Village of Lincolnwood Plan Commission

1. **Call to Order/Roll Call**
2. **Pledge of Allegiance**
3. **Approval of Minutes**
October 21, 2024, Meeting Minutes
4. **Case #PC-07-24: 3420 West Devon Avenue – Approval of Special Uses, Zoning Variations, and Parkway Parking for the Proposed Redevelopment of 3420 West Devon Avenue**
The public hearing regarding this matter was opened during the September 4, 2024, meeting of the Plan Commission. The hearing was continued to September 30, 2024, and then continued without discussion to November 7, 2024.

Plan Commission Staff Report

Proposed Second Floor Plan:

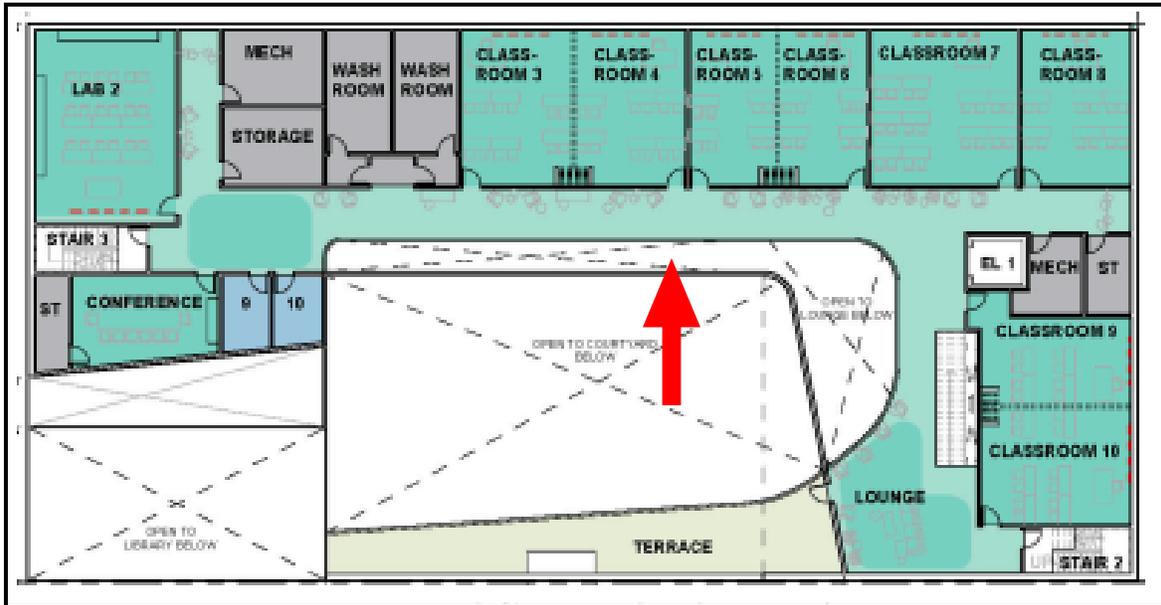
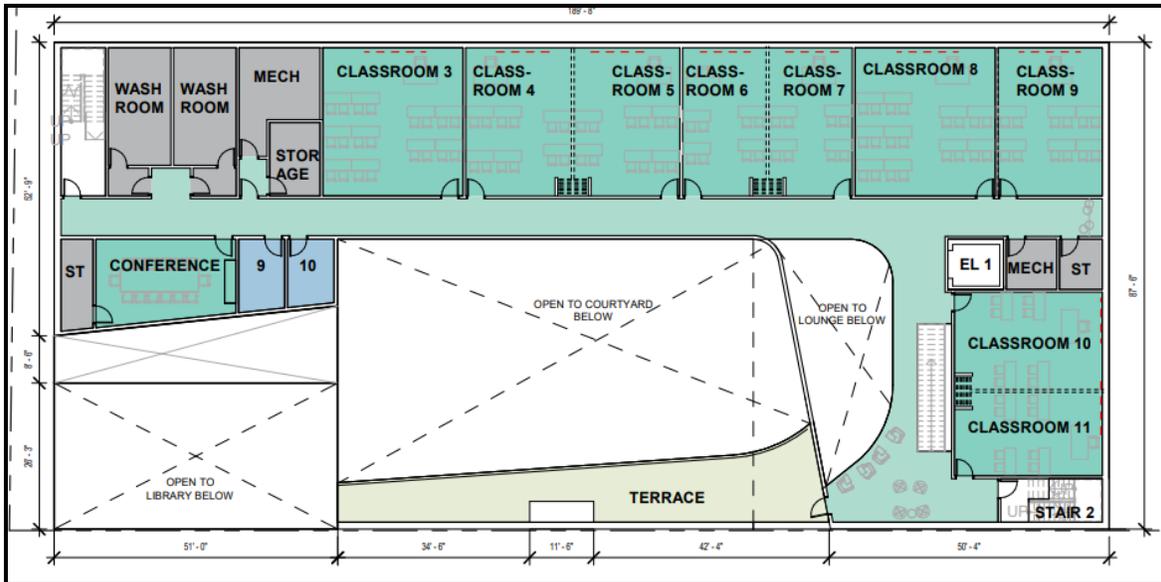
The depth of the second floor was reduced by 9 feet to increase the rear yard setback from 11 feet to 20 feet. The primary change in the second-floor plan was to reduce floor area open to first floor. The classroom capacity and configuration are relatively unchanged.

Proposed Third Floor Plan:

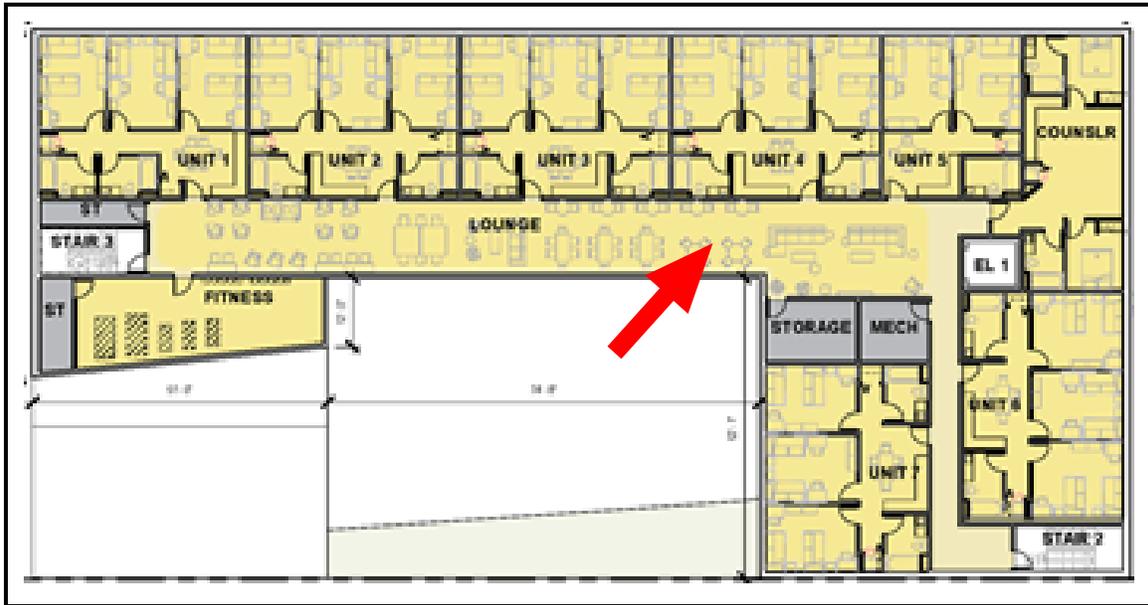
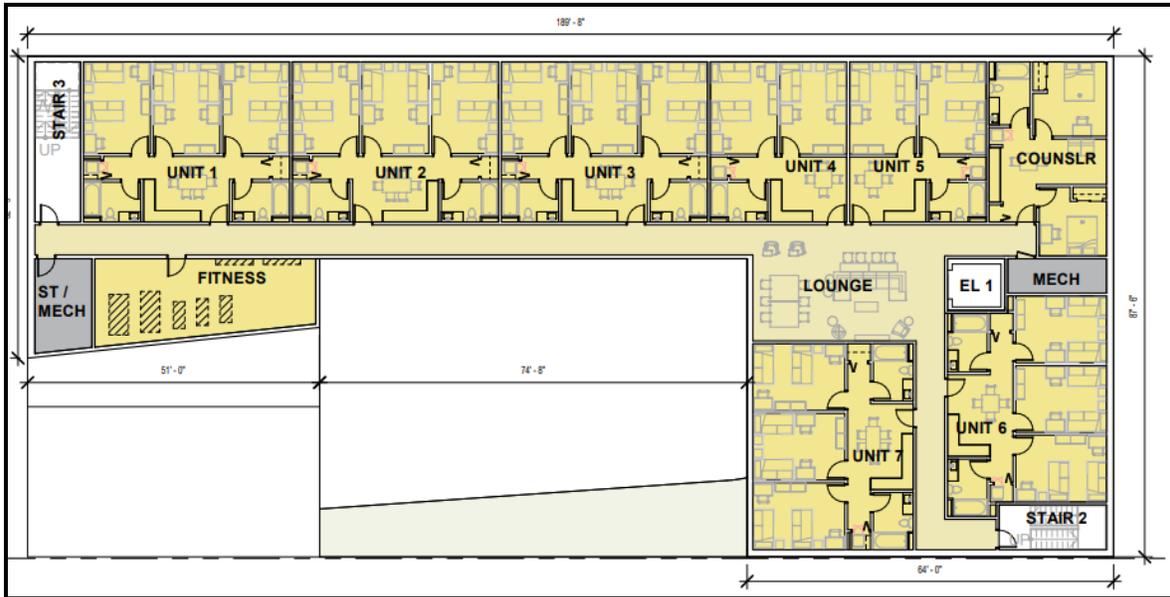
The lounge area on the 3rd floor was reduced in size and the mechanical and storage areas reconfigured to achieve the reduction of 9 feet from the building depth (and the increase in the rear yard setback by 9 feet). The number of classrooms remains the same.

Existing (left) and proposed (right) parkway parking configurations and tree plantings

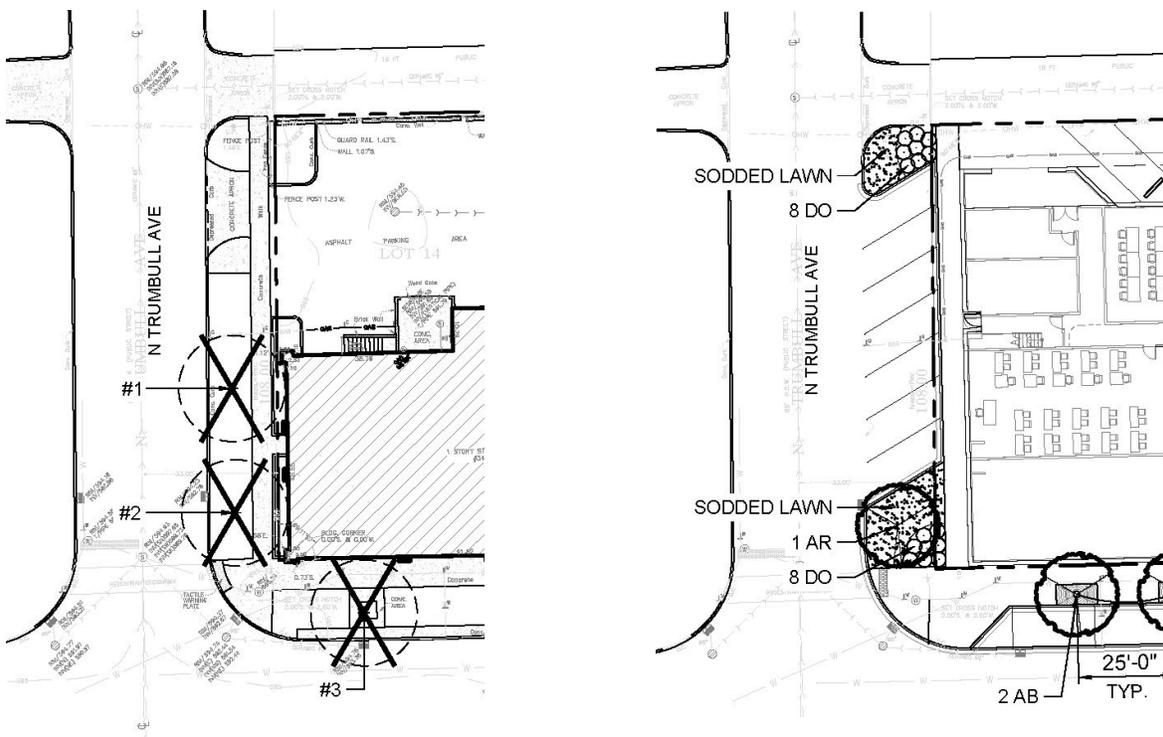
The proposed parkway parking plan would eliminate two existing curbside parking spaces, resulting in a net gain of five spaces. Two mature trees would be removed, and one new tree would be planted at the south end of the row of proposed parking spaces.

Diagram illustrating the preferred vehicular site egress (green solid line) and egress that may have impacts on adjacent residential uses (red dashed line)

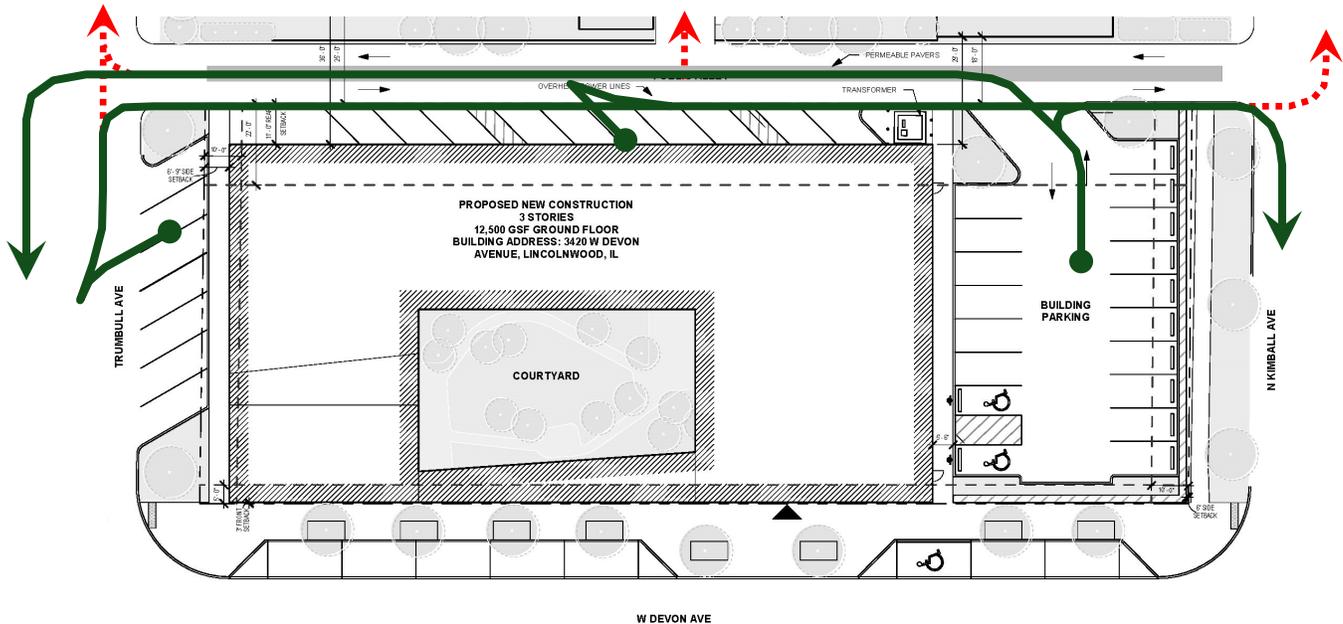
In terms of site-specific traffic impacts, staff has a concern about vehicles related to the proposed use utilizing local streets to navigate to areas north and northwest of the subject property. It may be appropriate to consider signage at either end of the alley directing non-resident motorists to turn south toward Devon Avenue. This could be supplemented by signage indicating that motorists exiting the parkway parking spaces must turn into the alley, which would in turn direct them south to Devon Avenue when approaching Kimball Avenue.

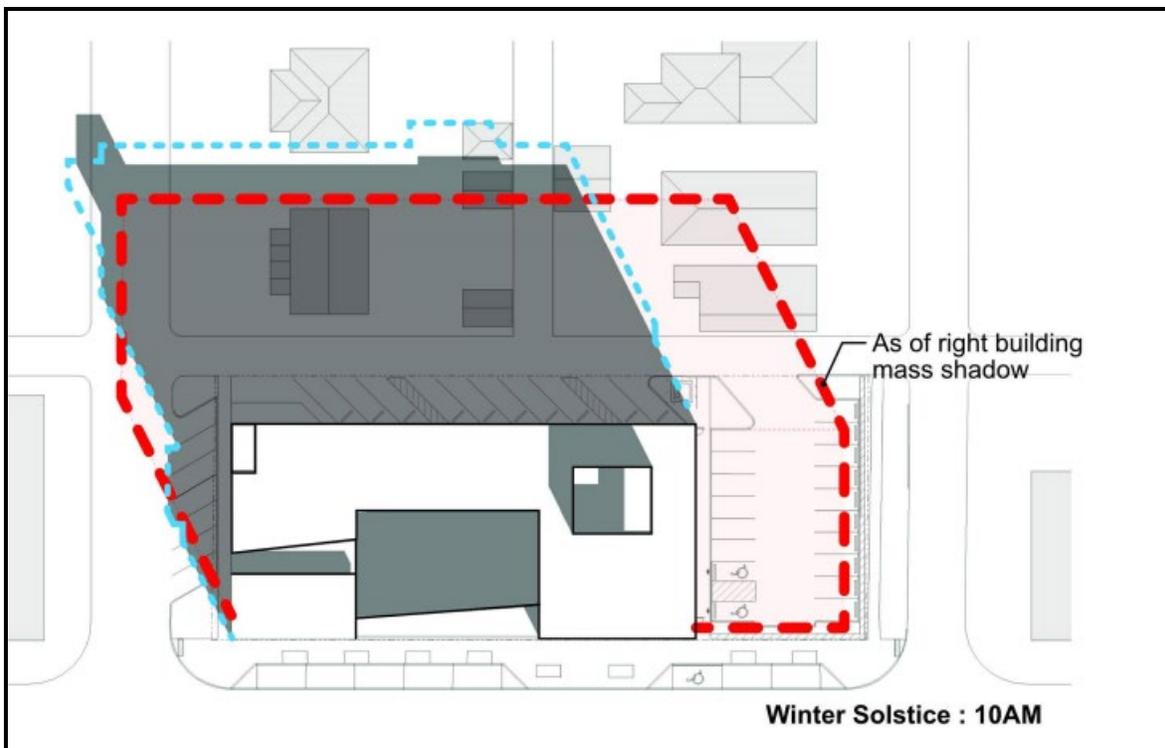
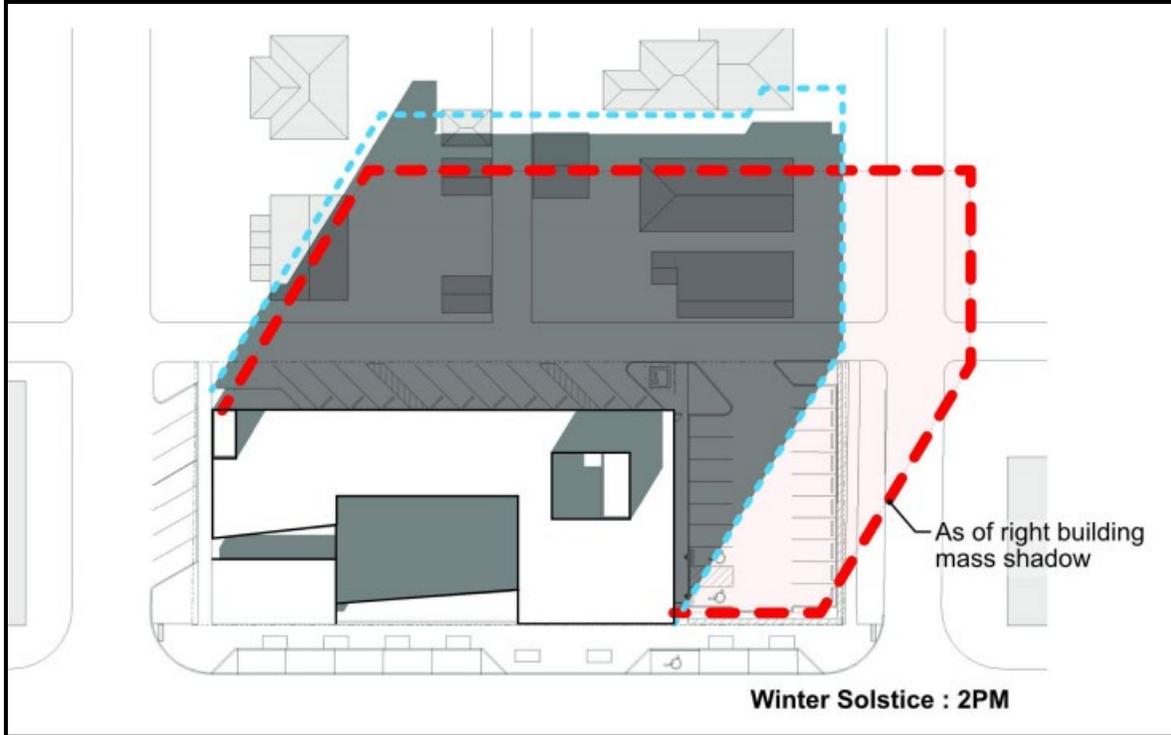
Around the time of the summer solstice, when the sun is at its highest peak angle, shadows will remain within the property with no new shadows cast by the building onto residential properties.

During the winter solstice, when the sun is at its lowest peak angle, shadows resulting from as of right development and from the proposed development will extend two residential lots north of the subject property. The illustration shows the increase in the shadows resulting from the taller building.

EXHIBIT B Shadow Studies

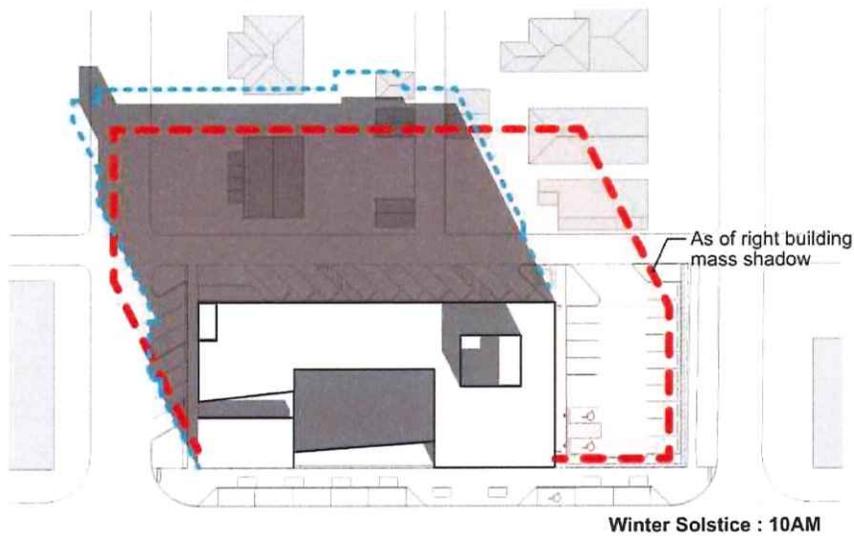
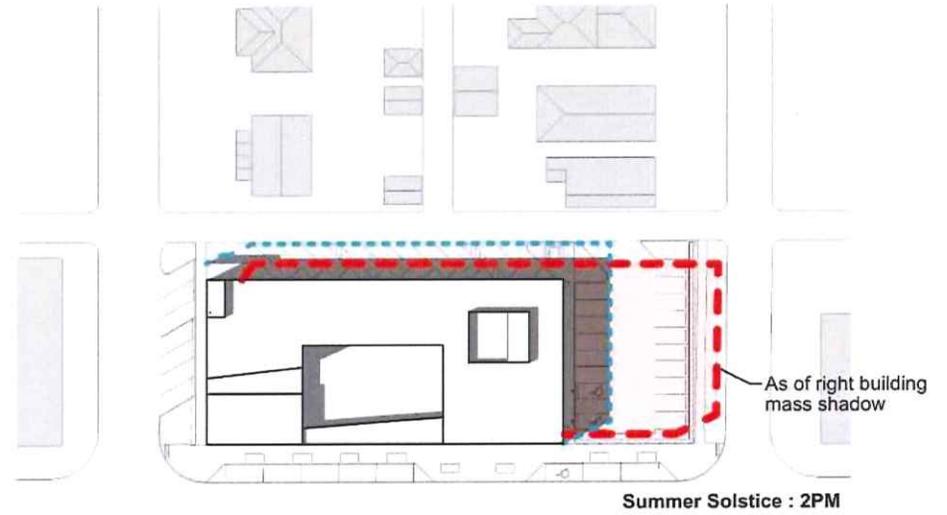
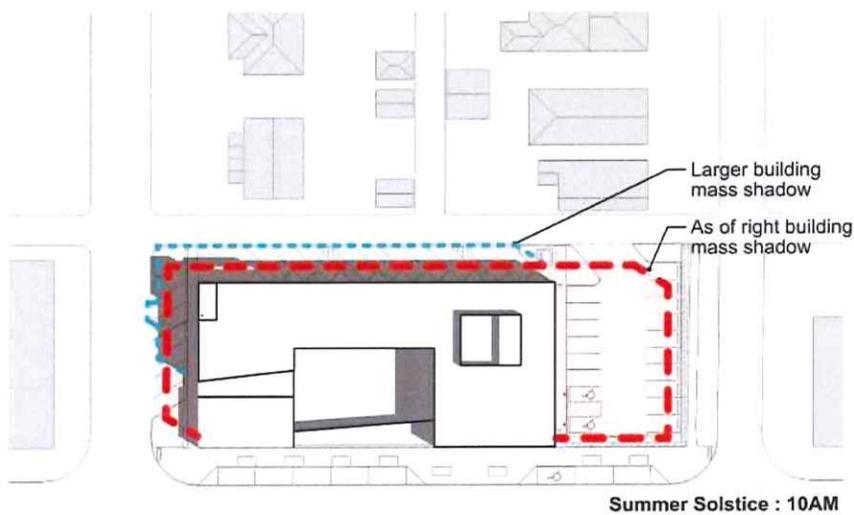
Response (from the architects at Solomon, Cordwell and Buenz): Yes, we were able to reduce the height of the building from 47' to 43'-3" (maximum height otherwise permitted is 38'), which has resulted in a reduction of our height variation request by approximately 50% (from 9' to 5'3") and a commensurate reduction in the mass/size of the building from approximately 40,585 square feet to approximately 38,171 square feet. This is reflected on the enclosed exhibits to this letter (Updated Building Context (**Exhibit A**) and Updated Shadow Studies Exhibit (**Exhibit B**)).

EXHIBIT C Site Plan

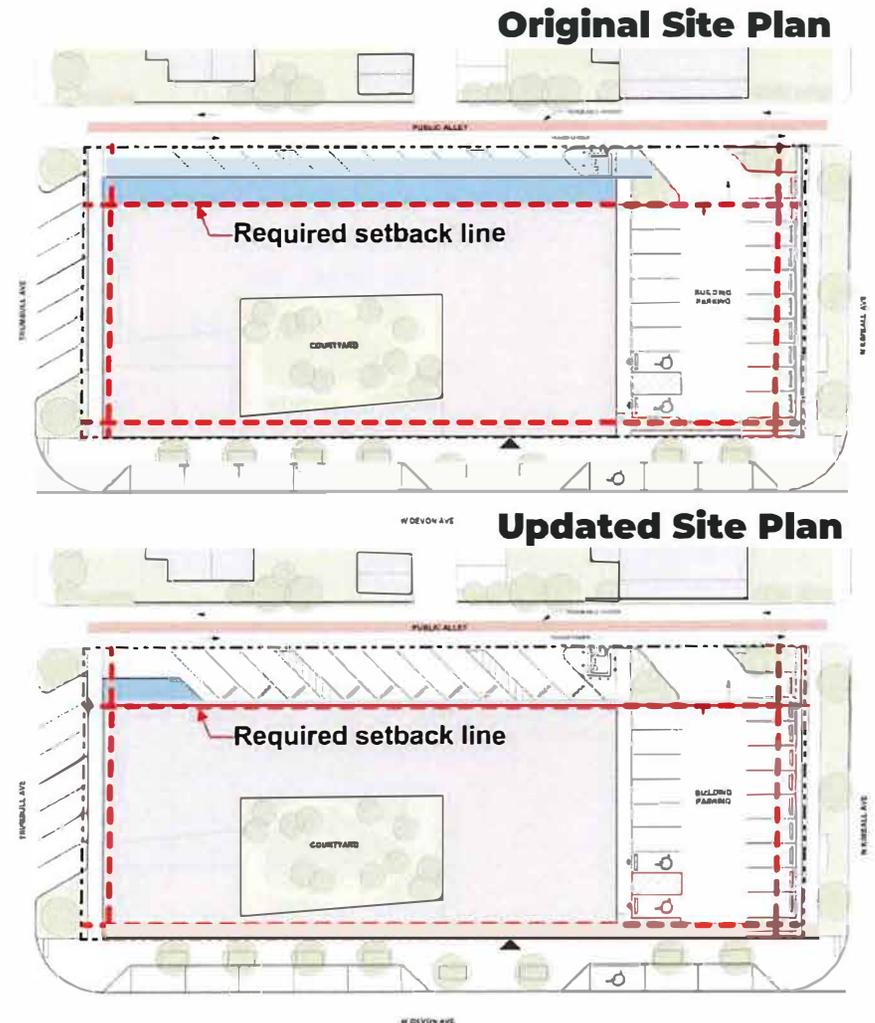
- Required 22 ft from property line (per section 4.07(3))
- Original rear yard setback at the upper two floors shows an 11 ft setback. Relief of 9 ft over the required setback.
- The updated rear yard setback at the upper two floor shows a 20 ft setback. Relief of 2 ft over the required setback.
- The ground floor setback remains unchanged where 83% of the ground floor is compliant with a 22 ft setback. The only exception is a single-story loading bay at the northwest corner of the site with an 11ft setback.

Response (from the architects at Solomon, Cordwell and Buenz): Yes, the rear yard setback at the upper two floors has been increased from 11'-0" to 20'-0", thus reducing the request for a rear yard setback variation in this location to only two feet, as shown on the updated site plan included with this letter as **Exhibit C**. The rear yard setback for the ground floor remains unchanged at 22'-0", which is what is required under the Zoning Code in this location, except for the single-story loading bay at the northwest corner of the site which is setback 11'-0", at a length of approximately 38 feet along the alley, per our original submittal.
